CALL NO. 104
CONTRACT ID NO. 242974
ADDENDUM # 1

Subject: Jefferson County, STPBRO 0503 (260)
Letting January 25, 2024

(1) Revised Plan Sheets from Project Related Information: S2 & S18

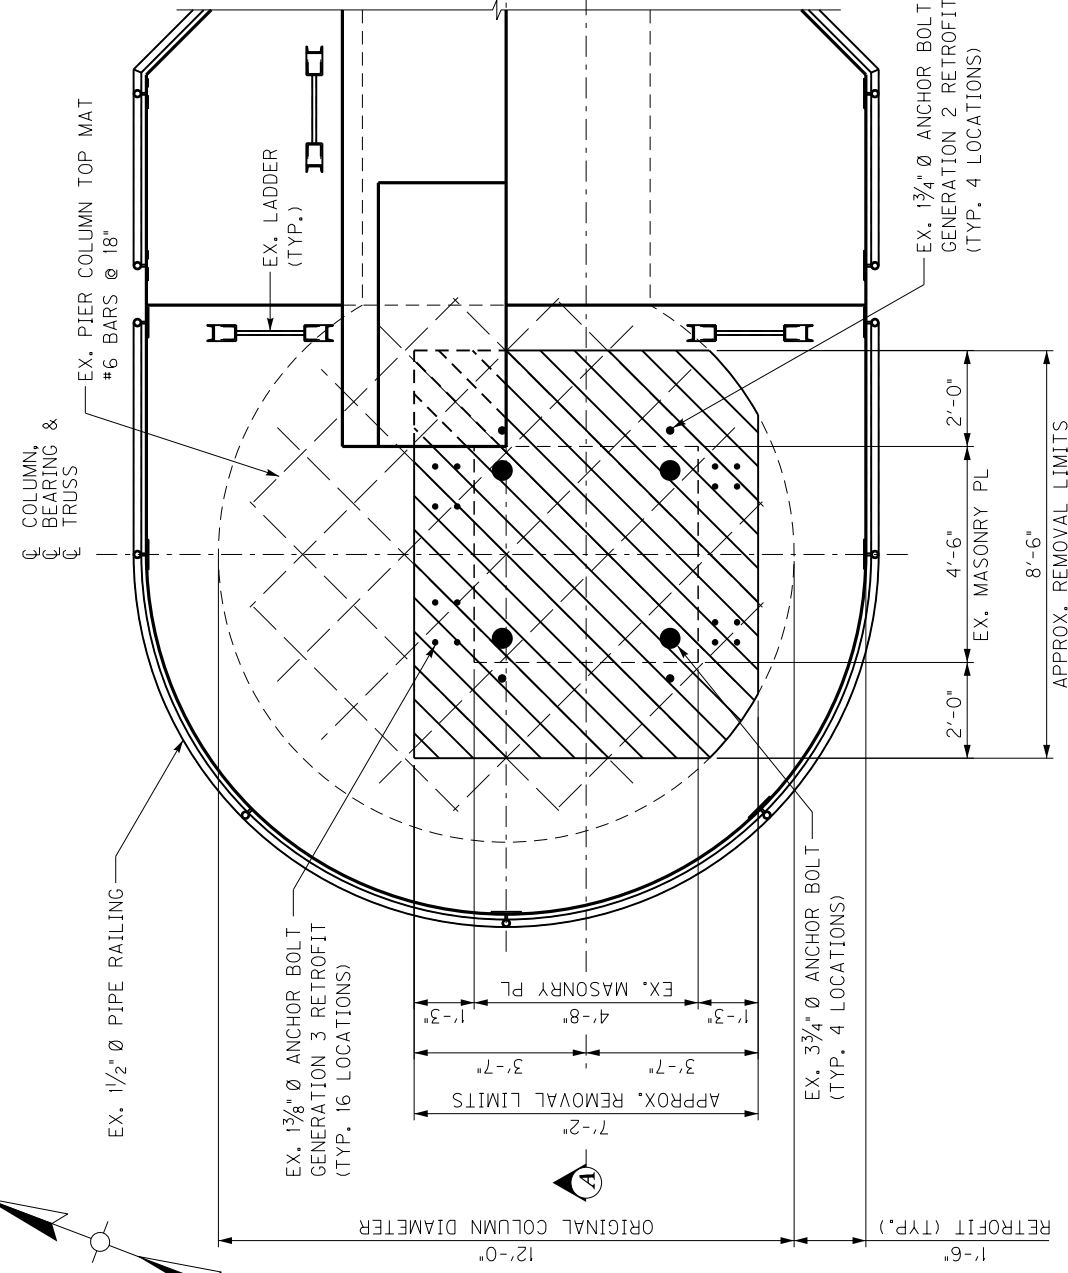
THE FOLLOWING PRODUCTS HAVE BEEN PRE-APPROVED, AND ARE ON THE LIST OF APPROVED MATERIALS, FOR THE NON-SHRINK GROUT AT PIER 6 DOWNSTREAM:

USE PEA GRAVEL AGGREGATE PER MANUFACTURER'S RECOMMENDATIONS. THE GROUT SHALL PROVIDE FULL CONTACT WITH THE MASONRY PLATE AND BE PLACED PER THE MANUFACTURER'S RECOMMENDATIONS. CURE PER MANUFACTURER'S SELECTED MATERIAL SHALL BE RECOMMENDED FOR BASE PLATE APPLICATIONS BY THE MANUFACTURER AND HAVE A MINIMUM COMPRESSIVE STRENGTH OF 3000 PSI BEFORE LIVE LOAD IS ALLOWED TO BE APPLIED. THE GROUT SHALL HAVE A MINIMUM COMPRESSIVE STRENGTH OF 5000 PSI AT 28 DAYS.

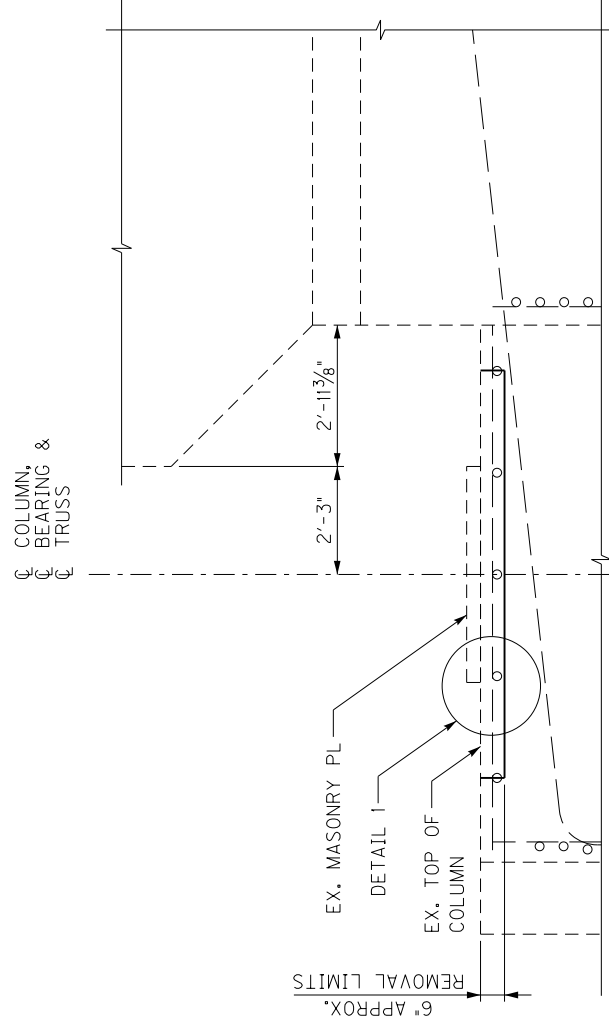
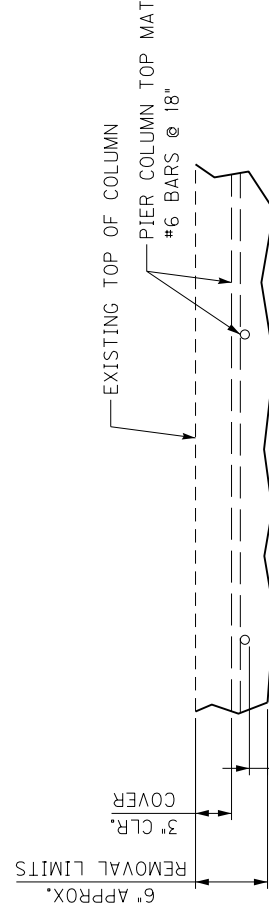
THIS WORK CONSISTS OF REMOVING THE DETERIORATED CONCRETE ADJACENT TO AND BELOW THE BEARING MASONRY PLATE AND REPLACING IT WITH NON-SHRINK GROUT. THE MASONRY PLATE IS SURROUNDED BY HOLD DOWN SYSTEMS ON THE TRANSVERSE SIDES (GENERATION 2) AND LONGITUDINAL SIDES (GENERATION 3). THE GENERATION 2 SYSTEM SHALL BE PERMANENTLY REMOVED; HOWEVER, THE ANCHOR RODS SHALL REMAIN IN PLACE TO BE USED WITH THE TEMPORARY HOLD DOWN SYSTEM. AFTER THE TEMPORARY HOLD DOWN IS IN PLACE, THE GENERATION 3 HOLD DOWN SHALL BE REMOVED FOR CLEANING AND PAINTING TO BE REPLACED AFTER THE CONCRETE REPAIR WORK IS COMPLETED.

THE CONTRACTOR SHALL SUBMIT A WRITTEN SEQUENCE OF THE SPECIFIC STEPS FOR THE CONCRETE REMOVAL TO THE ENGINEER PRIOR TO STARTING WORK. INCLUDE DETAILS OF ALL EQUIPMENT THAT WILL BE USED FOR THE CONCRETE REMOVAL, PAYING SPECIAL ATTENTION TO THE METHODS OF REMOVING THE CONCRETE BELOW THE MASONRY PLATE. CARE MUST BE TAKEN NOT TO DAMAGE THE EXISTING ANCHOR BOLTS.

ENSURE, IN THE PRESENCE OF THE ENGINEER, THAT ALL CONCRETE ADJACENT TO THE REMOVAL LIMITS IS SOUND. BASED ON RESULTS OF HAMMER SOUNDINGS, THE REMOVAL LIMITS MAY BE INCREASED AS DETERMINED BY THE ENGINEER.

SAW CUT THE CONCRETE REMOVAL BOUNDARIES 1 INCH DEEP MINIMUM. USE PNEUMATIC HAMMERS AND CHISELS, NOT EXCEEDING 30 POUNDS, FOR REMOVAL.

REMOVE THE 3 INCH CONCRETE COVER EXPOSING THE PIER COLUMN TOP MAT #6 REINFORCING STEEL. ONCE INITIAL REMOVALS ARE MADE, PROCEED WITH UNDERCUTTING ALL OF THE TOP MAT EXPOSED BARS. PROVIDE 1 INCH MINIMUM CLEARANCE FOR UNDER BAR CLEANING AND FULL BAR CIRCUMFERENCE BONDING TO SURROUNDING CONCRETE. CONCRETE REMOVALS SHALL EXTEND ALONG THE BARS TO LOCATIONS WHERE THE BAR IS WELL BONDED TO SURROUNDING CONCRETE.

BLAST CLEAN ALL EXPOSED STEEL REINFORCEMENT TO REMOVE SCALE, RUST, GREASE, OIL AND OTHER MATERIAL THAT WOULD PREVENT ADHESION OF THE CONCRETE. CHECK THE CONCRETE AFTER CLEANING TO ENSURE THAT SURFACE IS FREE FROM ADDITIONAL LOOSE AGGREGATE AND TO ENSURE THAT ADDITIONAL DELAMINATION IS NOT PRESENT.

WITHIN 12 HOURS OF PLACING NON-SHRINK GROUT, BLAST CLEAN ALL SURFACES TO REMOVE DUST AND LOOSE MATERIAL WITH COMPRESSED AIR. COMPRESSED AIR MUST BE FREE FROM OIL AND WATER.

ENSURE THE SURFACE OF THE EXISTING CONCRETE IS IN A SATURATED SURFACE-DRY (SSD) CONDITION. REMOVE ALL FREE (PONDI) WATER JUST BEFORE PLACING THE GROUT. DO NOT USE AN EPOXY BOND COAT WITH THE GROUT.

PLACE NON-SHRINK GROUT AND CURE IN ACCORDANCE WITH THE STANDARD SPECIFICATIONS AND THE MANUFACTURER'S RECOMMENDATIONS. MATCH EXISTING TOP OF COLUMN SURFACE AND ENSURE THAT THE NEW SURFACE DRAINS AWAY FROM THE BEARING MASONRY PLATE.
